**RE: Rio Grande Apartments
2211 Rio Grande Blvd. NW
Grading and Drainage Plans
Engineer's Stamp Date: No Date
Hydrology File: H12D024**

Based upon the information provided in your submittal received 09/07/2021, the Grading & Drainage Plans **are not** approved for Building Permit, Grading Permit and SO-19 Permit. The following comments need to be addressed for approval of the above referenced project:

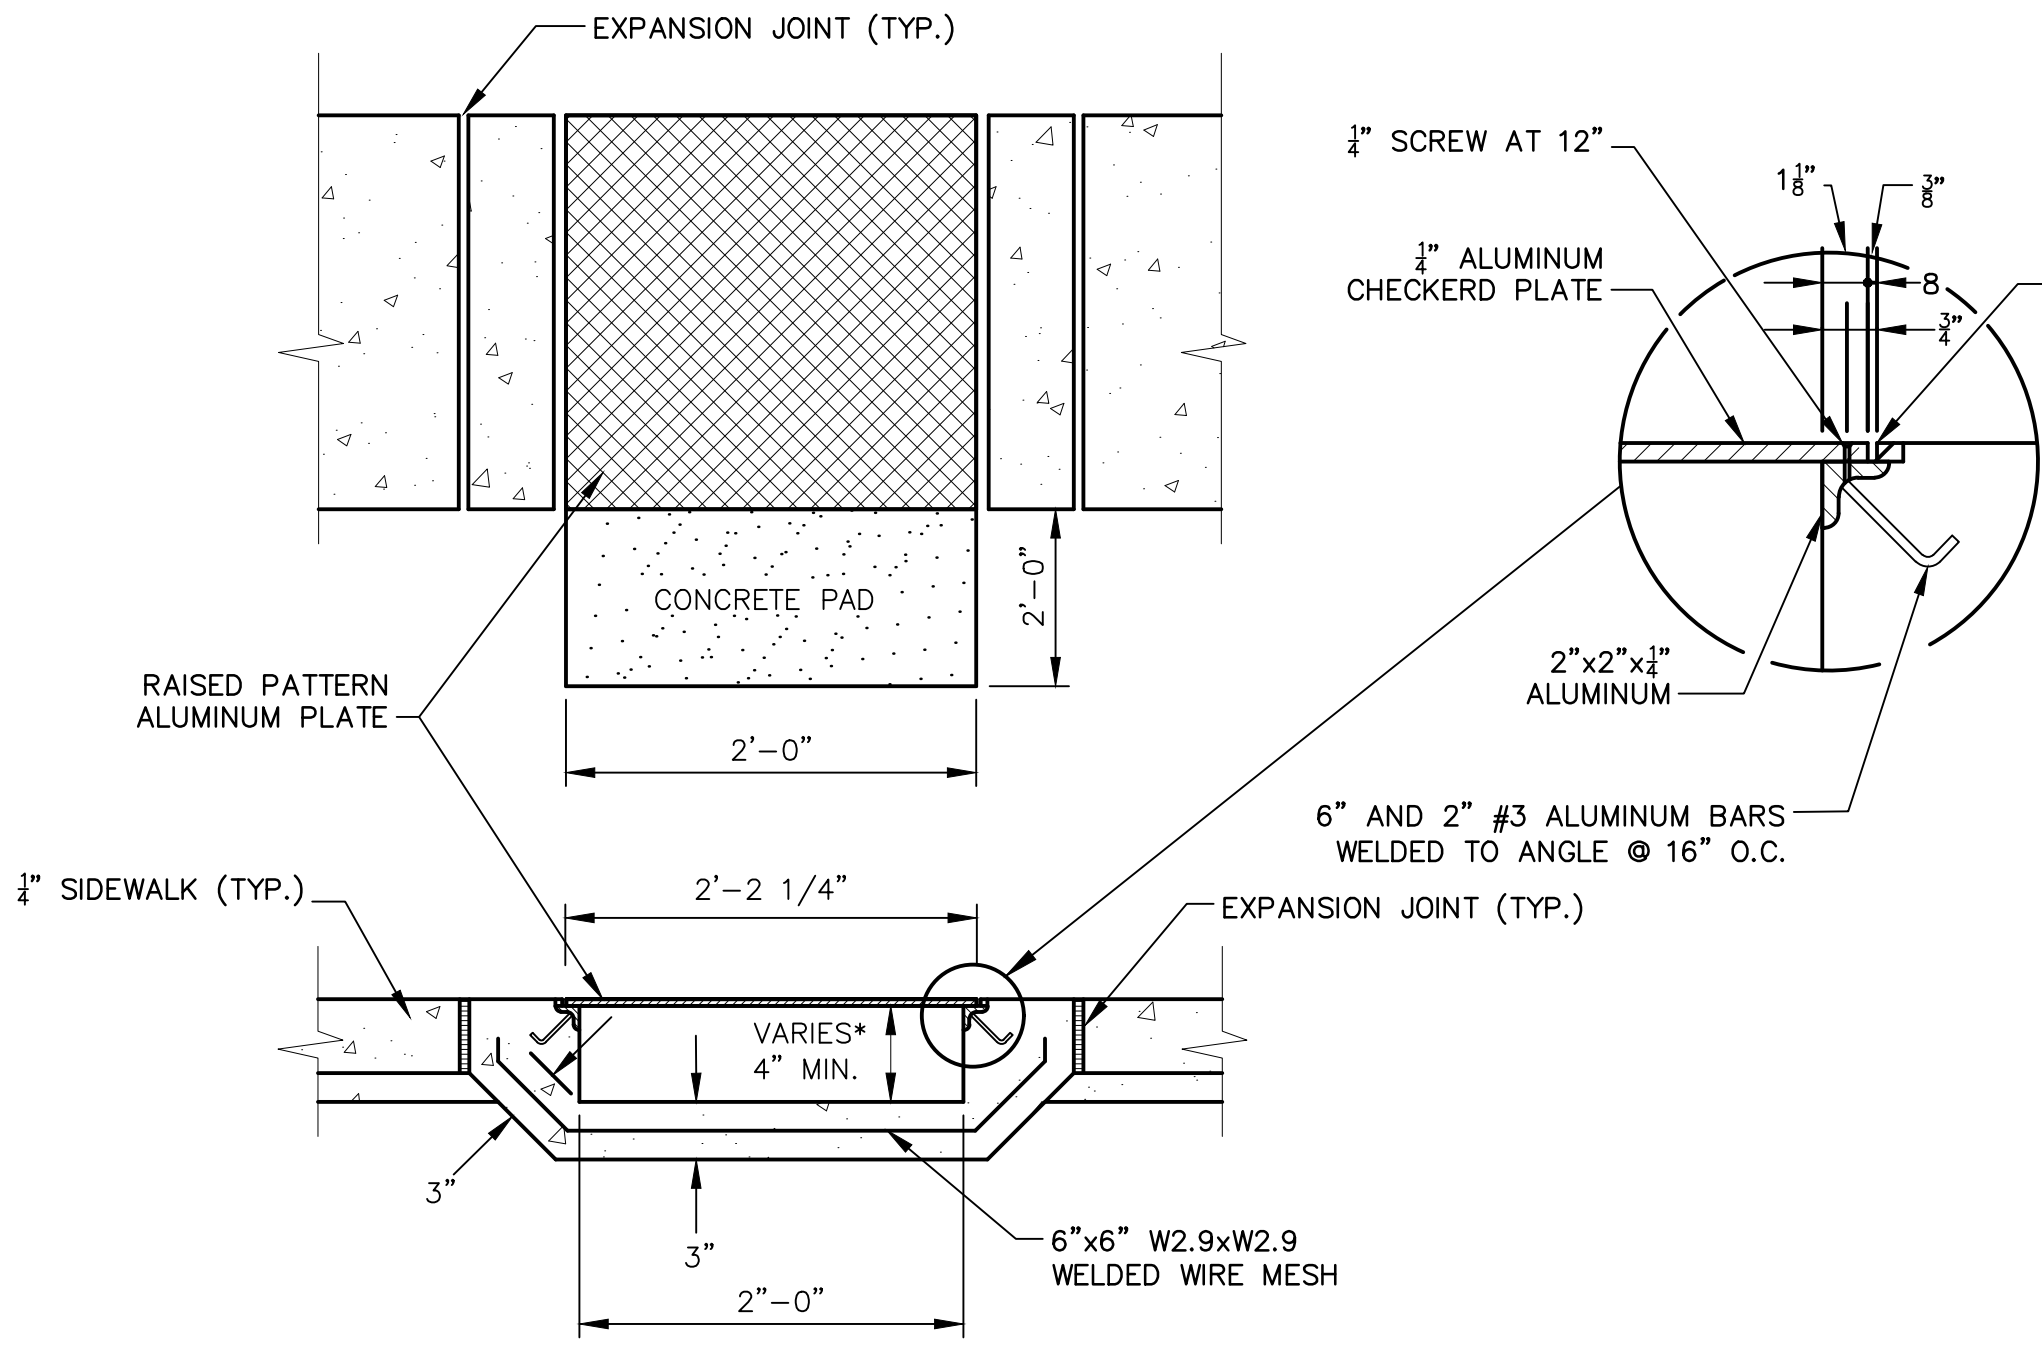
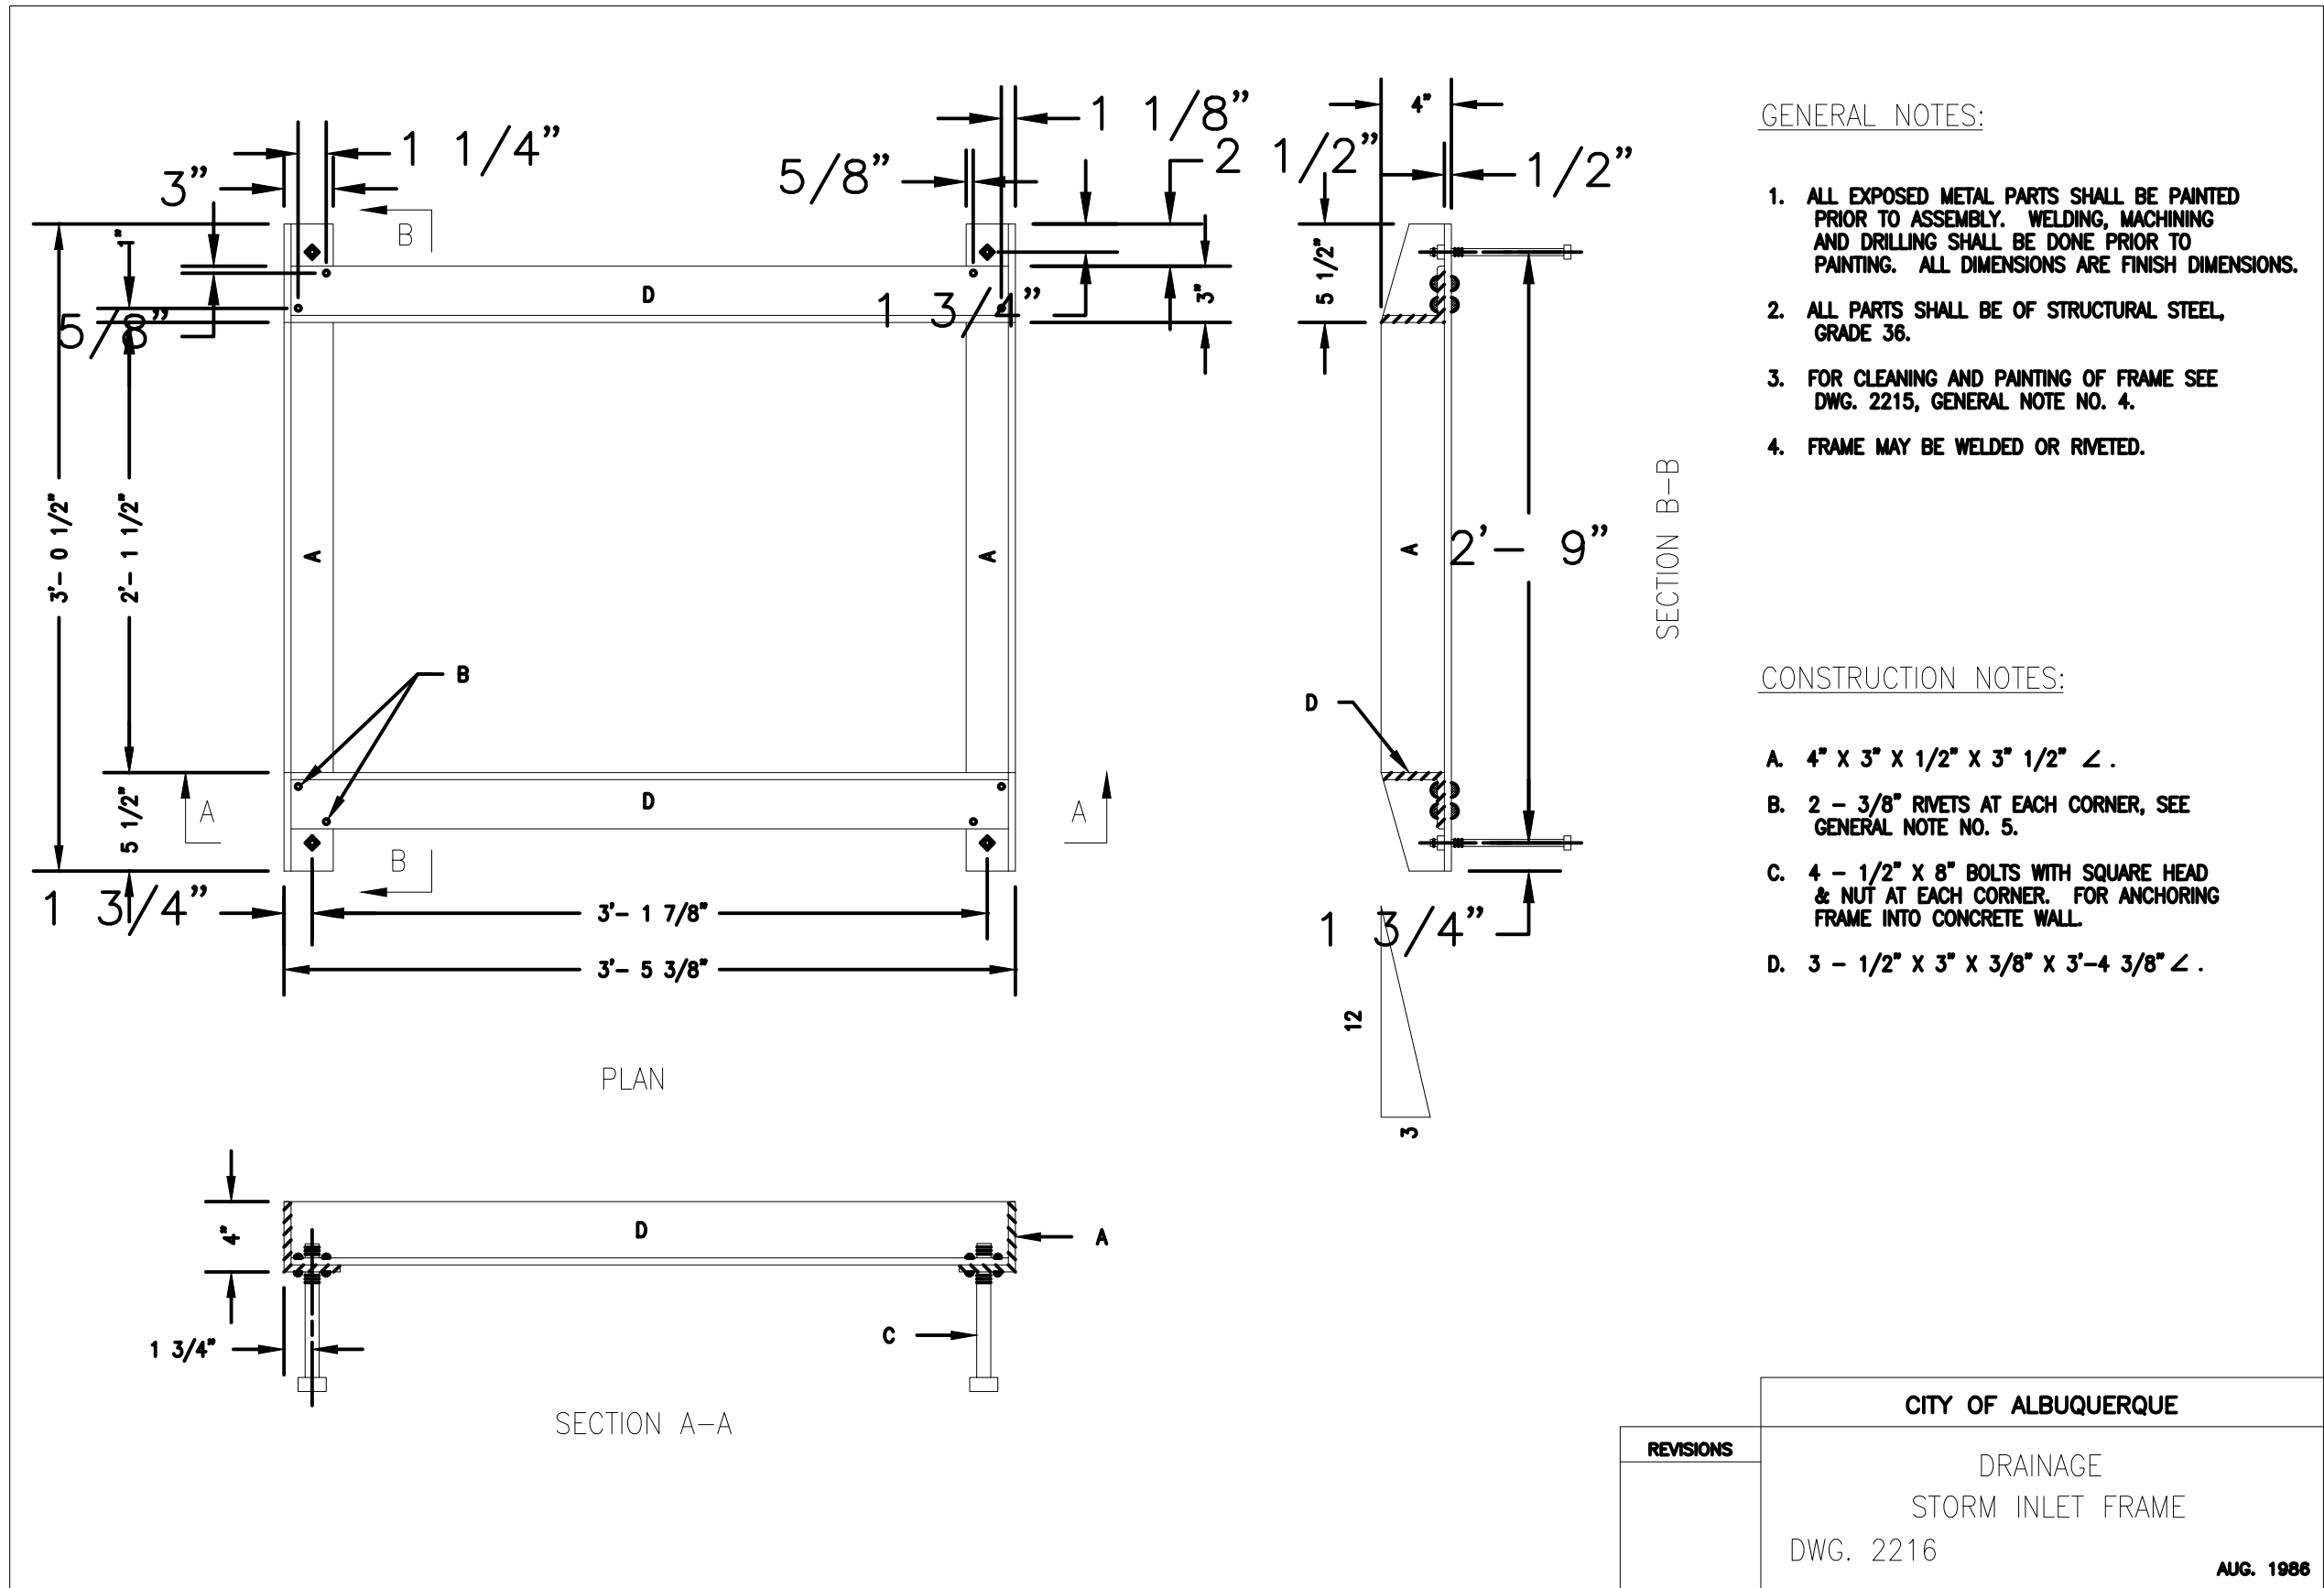
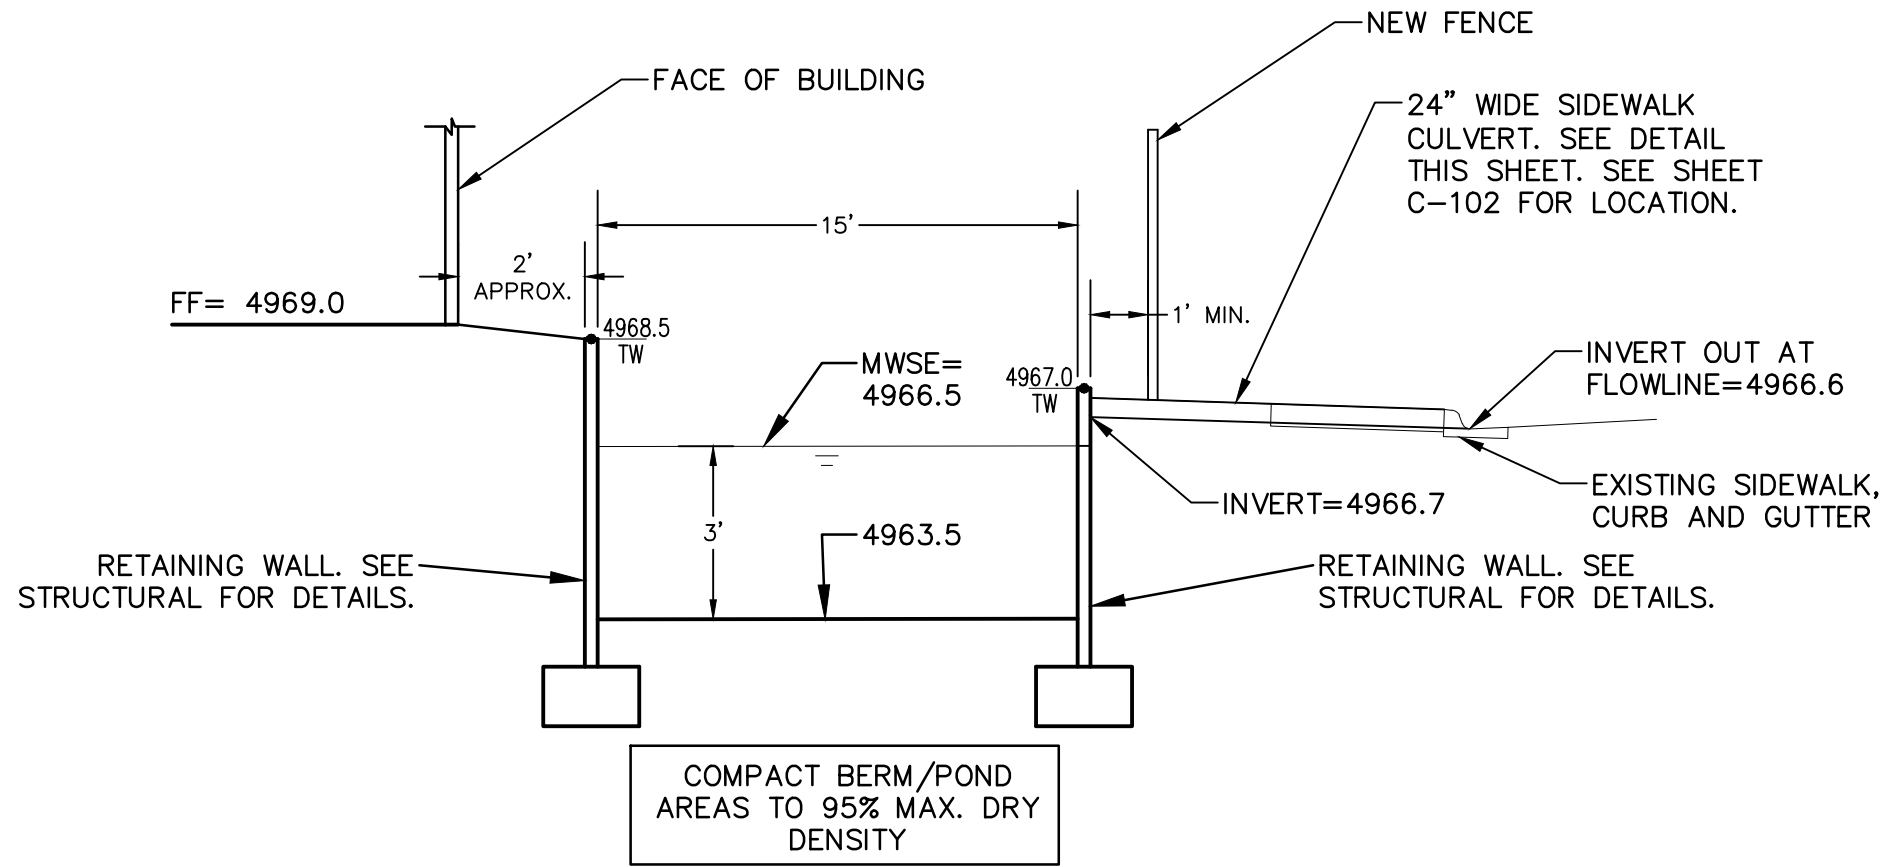
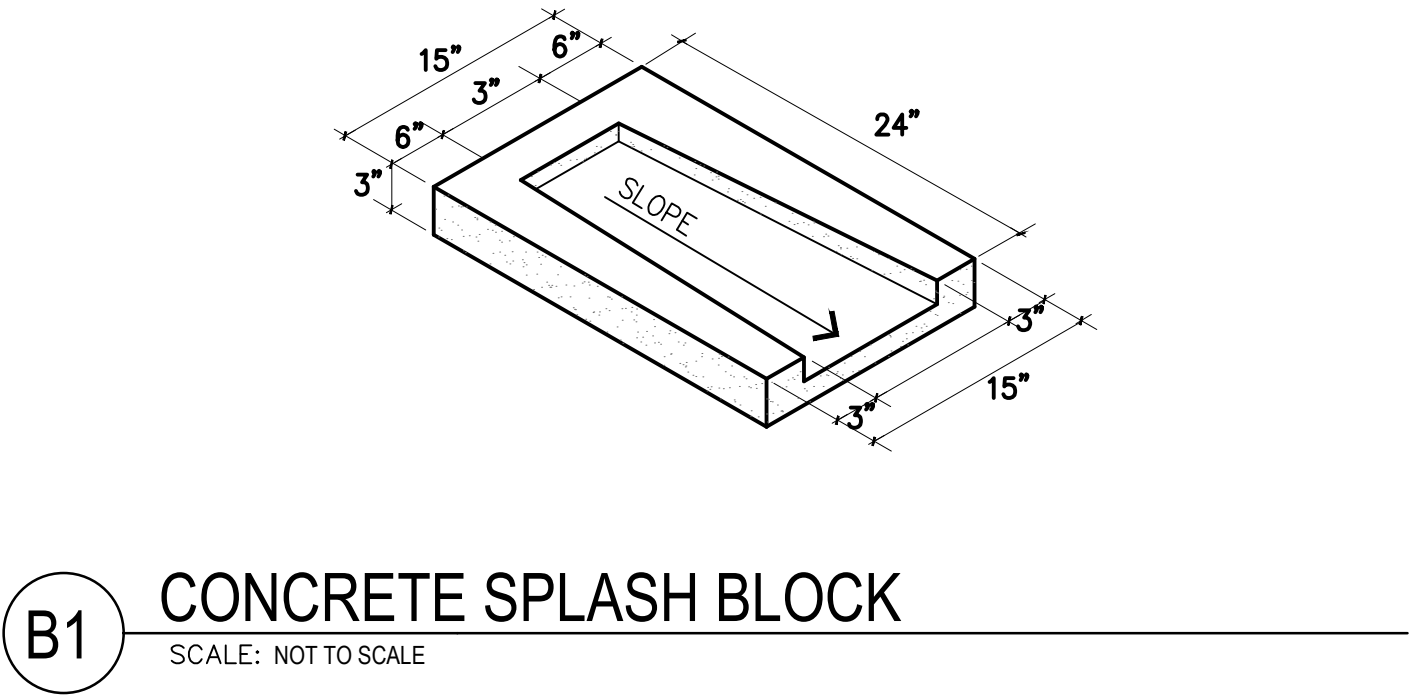
16. In the cross section, please showing property/ROW lines and add a note stating that the contractor shall waterproof the proposed retaining wall below the 100-yr 10 day water surface elevation of 4966.5 per City standards. In accordance with DPM, grading and wall construction near the property line may not endanger adjacent property or constrain its use. Please make sure that the footer for the wall stays within the project's property. Also move this onto the Grading Plan per Comment #9.

17. The remainder of the details on this sheet or either just standard City details, which don't need to be shown. Just call them out on the Grading Plan as per COA Standard Drawing xxxx.

18. Please just remove the sidewalk culvert since you are installing one in the City's R.O.W. See Comment #12.
